Staff Report

To: Salt Lake City Planning Commission
From: Eric Daems, Senior Planner
801-535-7236 or eric.daems@slcgov.com
Date: October 11, 2023
Re: PLNPCM2023-00113 Design Review
PLNPCM2023-00114 Planned Development

Design Review // Planned Development

PROPERTY ADDRESS: 320 S. and 330 S. 300 East
PARCEL ID: 16-06-327-001-0000 and 16-06-328-028-0000
GENERAL PLAN: Central Community
ZONING DISTRICT: R-MU Residential Mixed-Use
OVERLAY DISTRICT: Groundwater Source Protection

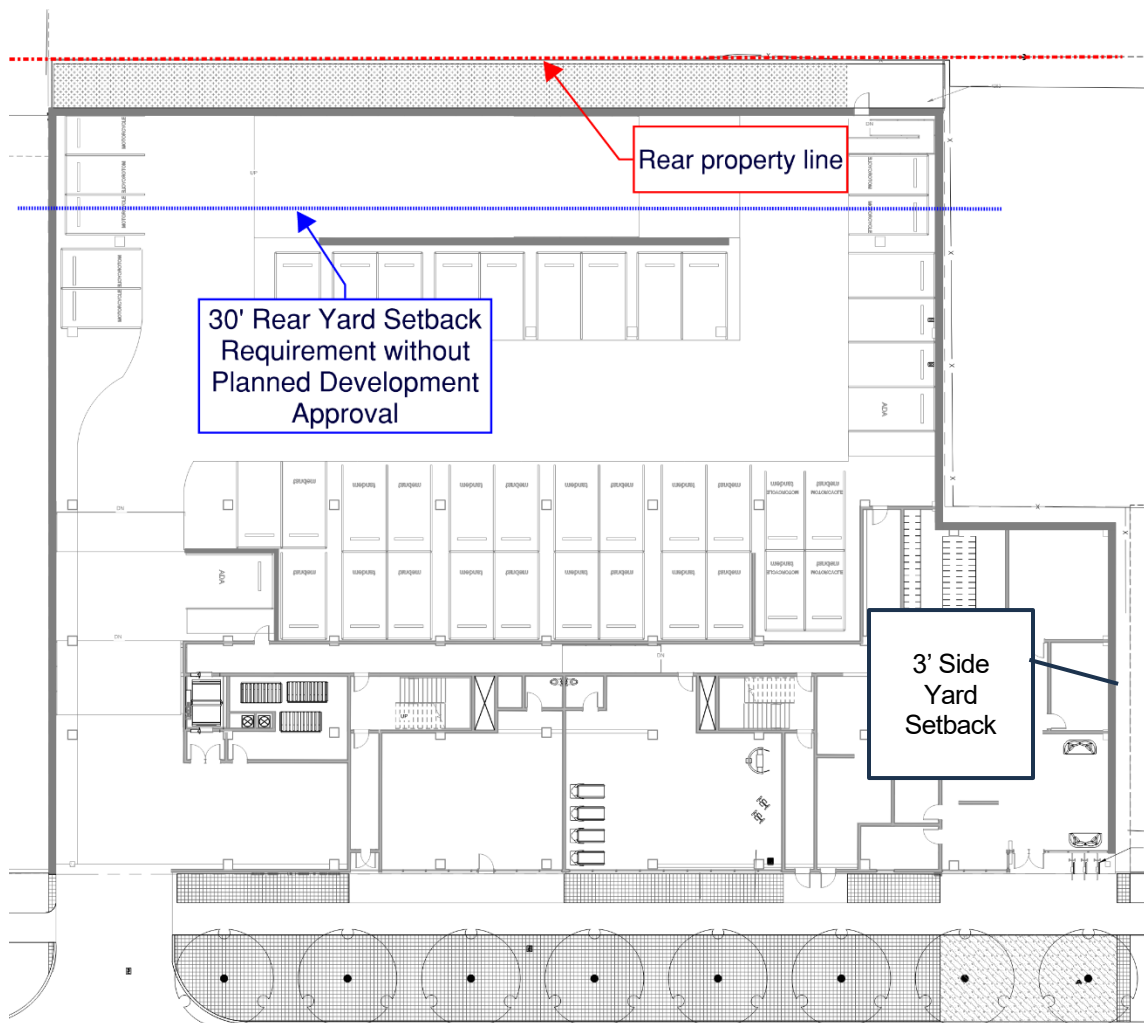
The applicant is requesting Planned Development approval to modify the rear yard setback from 30' to 10' and the side yard setback (on the north property line) to 3'. The side yard setback requirements in the R-MU zone are unique. No side yard setback is required, however, if one is provided, it is to be at least 4'. The idea is that if one is provided, it should be wide enough to accommodate landscaping. In this case, the applicant is asking for a 3' setback to accommodate a concrete walkway that creates additional separation from the property line, but also provides access for construction and building maintenance.

The reason the applicant has requested to reduce the rear yard setback is to increase the development potential of the site, but more importantly to allow for a parking garage to function at the rear of the property. To lessen the impacts of the reduced rear yard setback the applicant has only included the 3-story parking garage in the setback area. Additionally, a landscaped amenity deck is being provided for residents to enjoy outdoor open space. The amenity deck will be located above the parking garage. The images below show the anticipated development in relationship to the required rear yard setback.

The property is in a very urbanized area and less than a 1/2 block from the D-1 zone. A rear yard setback is generally used to provide buffering and separation between uses but, in this case, future surrounding uses will likely be similar in scale to this one.

Figure 7- Level 1 Floor Plan

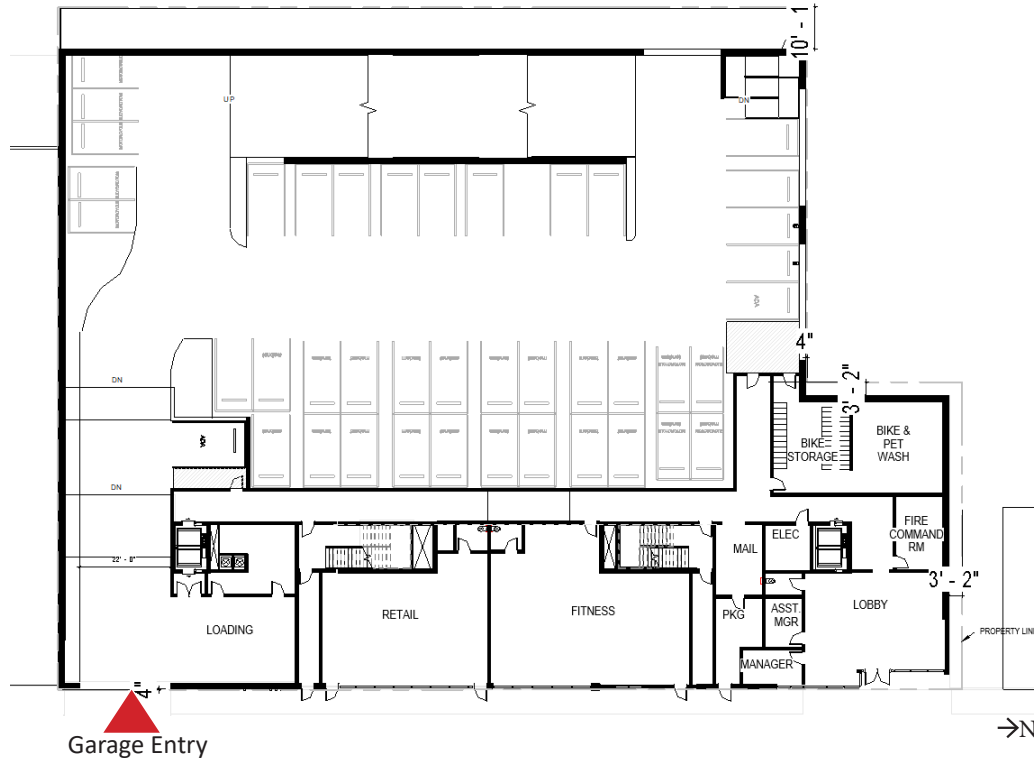
c. Provide sufficient open space buffering between the proposed development and neighboring properties to minimize impacts related to privacy and noise. (What is proposed in this setback area?)

- While no side setback is required in the RMU district, the project has a 3' side setback at the north property line to reduce disruption to neighboring foundations during construction. To minimize privacy and noise impacts to the historic neighbors at the north, the parking garage entry is located at the south end of the site. Additionally, the amenity deck is located towards the south-west corner of the building on level 3. Windows along the north and south facade have been minimized to reduce privacy concerns.

Figure 8

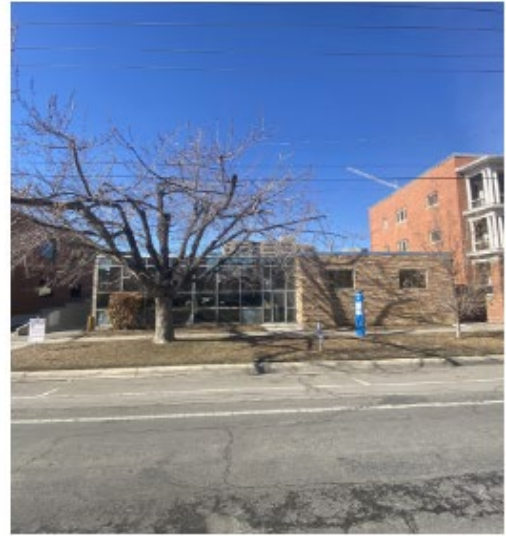
7. Whether parking areas are appropriately buffered from adjacent uses. (What about light casting from parking area to neighboring properties? Could a mesh screen be used? Could vines or a more decorative surface than cast concrete be used to dress up the sides of the parking garages?)

- The parking garage is intentionally located toward the rear of the site, to preserve human connection to the street and mitigate disruption to the neighboring residences. Openings into the garage which allow daylight and ventilation into the garage (yellow arrows in Figure 8) are set back from the neighbors and only abut the parking lots to the north and west. The openings are high enough to shield headlight beams from future neighbors.

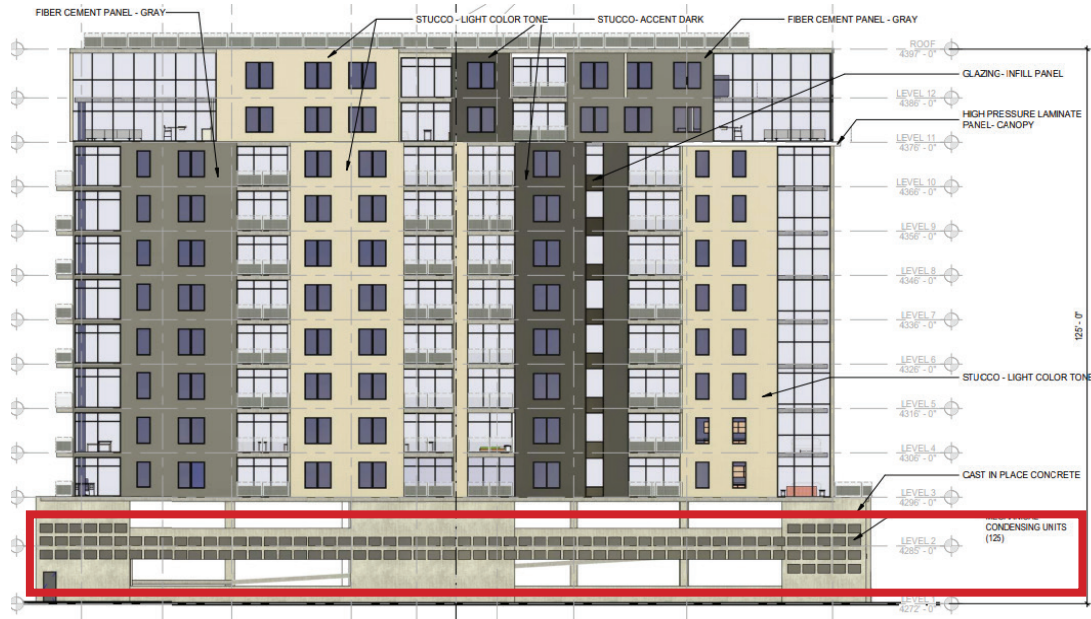
Per Salt Lake City's R-MU 21A.24.170, the rear-yard setback is 25% of lot depth, but not to exceed 30'. The proposed project is seeking an exception to the rear set-back requirements, allowing the property, 165' deep, to build with only maintenance access off of the rear property boundary. This would result in only 10' between built-out properties.

We strongly object to this exemption being approved.

The building setback guidelines are in place for a reason. This setback allows for the safety and comfort of the adjacent properties and their residents.
